CONCEPTUAL REZONING PLAN FOR
CALE LANGFORD

PETITION NO: Z-53

Z-53 BROWNSTONE ASSOCIATES, INC.

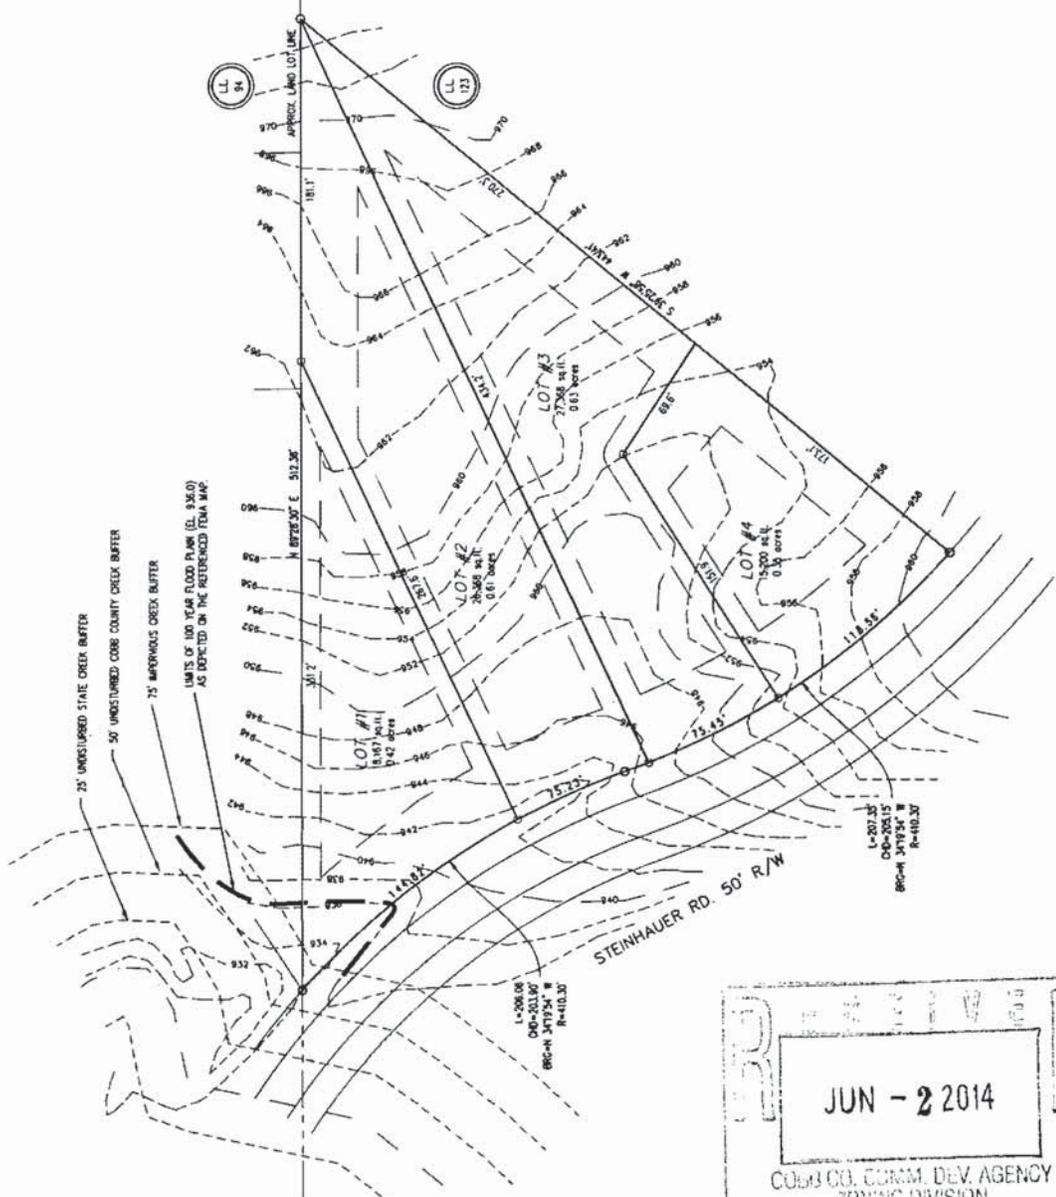
- No Stormwater controls shown _____
- Copy of survey is not current – Additional comments may be forthcoming when current site conditions are exposed.
- No site improvements showing on exhibit.

1. Either a separate detention pond or multiple dry-well systems will need to be installed to meet stormwater runoff and water quality requirements.

Steinhauer Road is classified as a minor collector and according to the available information the existing right-of-way does not meet the minimum requirements for this classification.

Recommend applicant consider entering into a development agreement pursuant to O.C.G.A. 36-71-13 for dedication of the following system improvements to mitigate traffic concerns: a) donation of right-of-way on the northeast side of Steinhauer Road, a minimum of 30' from the roadway centerline.

Recommend applicant verify that minimum intersection sight distance is available, and if it is not, implement remedial measures, subject to the Department's approval, to achieve the minimum requirement of 390 feet.

Recommend a maximum of two (2) curb cuts for the four (4) lots.
